CERTIFICATE OF APPROPRIATENESS

RE: Application Number 20-6783; 1225 Hubbard, Hubbard Farms Historic District

Rear Yard

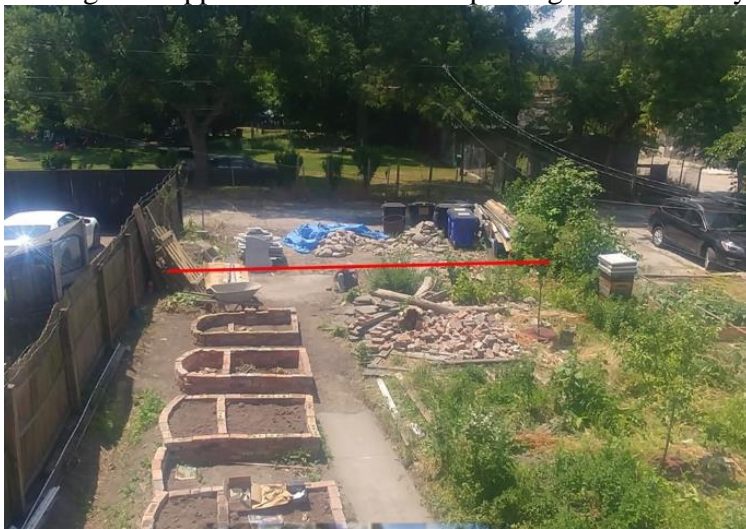
Fence: A gabion base (18-24" in height); the top portion will be shadowbox (vertical) wood picket panels (4' height); supports will be wood posts (4x4). The applicant supplied the below photographs of the two elements for the fence design.

- Rear: Install a gabion base (2’) and a shadow-box wood fence (4’), using 4”x4” wood posts. The total height would stand 6’; 30’ in length; with 2 entrance gates. The wood will be stained.

Porch with Current Repairs, Replaced Railing
(existing and proposed)

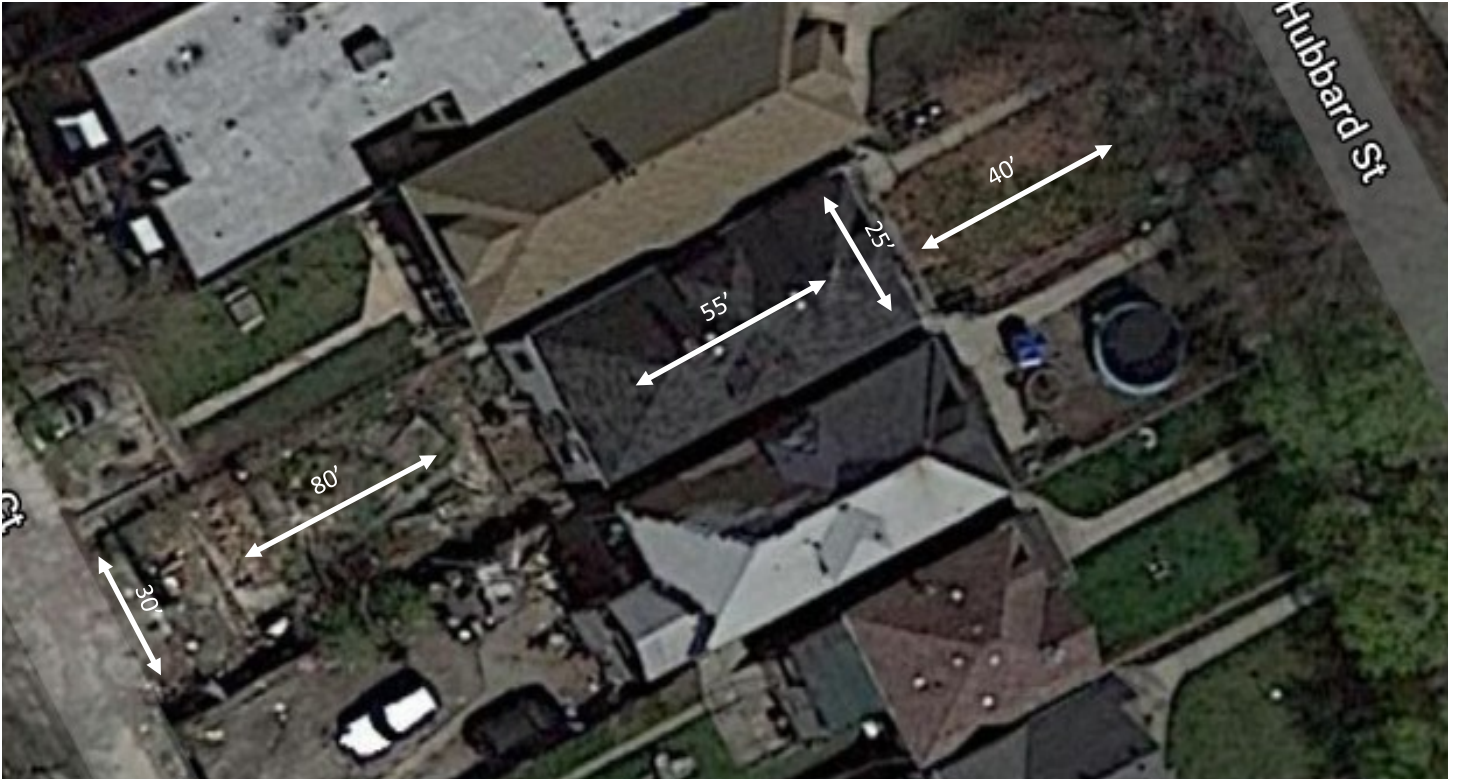
The only work approved on this page is the installation of a second story door as outlined in red. *Conditional approval: Catalog cut of proposed door to be submitted for staff review.*

- The porch railing (once the design is approved) will be painted, not stained, to match the trim (B:18, Dark Reddish Brown). This will allow the railing to play a more neutral role against the house.
- A catalog cut of the proposed second story porch door will be submitted for staff review.
- The applicant shall provide HDC staff with the final specifications prior to initiating the work and staff shall be afforded the opportunity to review and approve this submission prior to the issuance of the permit.
